FINAL ISSUE
F.P. No. 932140-1-3072
REV. R30 DATE 1/1/73

Westinghouse Electric Corporation		F.P. 3072	
TITLE: CONSOLIDATED EDISON CO.			
INDIAN POINT STATION - UNIT NO 2			
ELEMENTARY WIRING DIAG		MOTOR OPERATED VALVE	
G SHEARER	3/15/68	499B444	
3	2	SHEET-140	
ATOMIC POWER DIV.,		PITTSBURGH, PA., U.S.A.

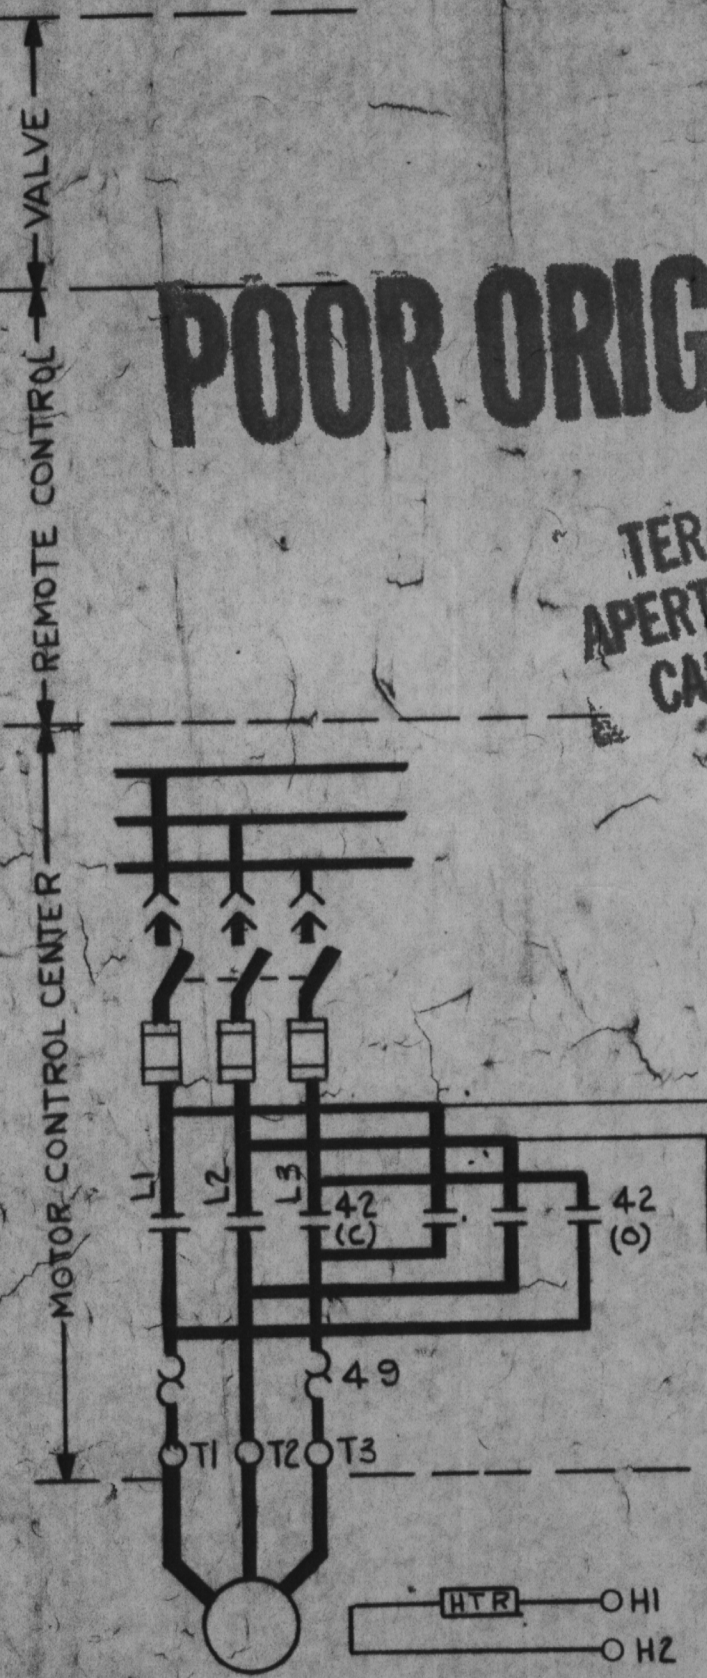
INSTALL &
CONNECT
THESE
JUMPERS

NOTE:
REV. 3B APPLIES TO VALVES 894A,
894B, 894C, & 894D ONLY.

THIS REV. IS CLASS "A" PER CI-240-1
IN CONN. WITH MODIF. OF ECC SY.
VALVE CIRCUITRY (PHASE 2) MAKE CHANGES
AS SHOWN. RELEASED PER
CON. EDISON CO. MODIF. PROC.
ESS-76-2-07

THIS REV. IS NON-CLASS "A" AS
PER CI-240-1. IN CONN. WITH
MODIF. OF ECC SYSTEM VALVE
CIRCUITRY (PHASE 1), MAKE
CHANGES AS SHOWN.
THIS REV. APPLIES FOR VALVES
894A, 894B, 894C, 894D
ONLY.
PIN-6039 RB/BTM
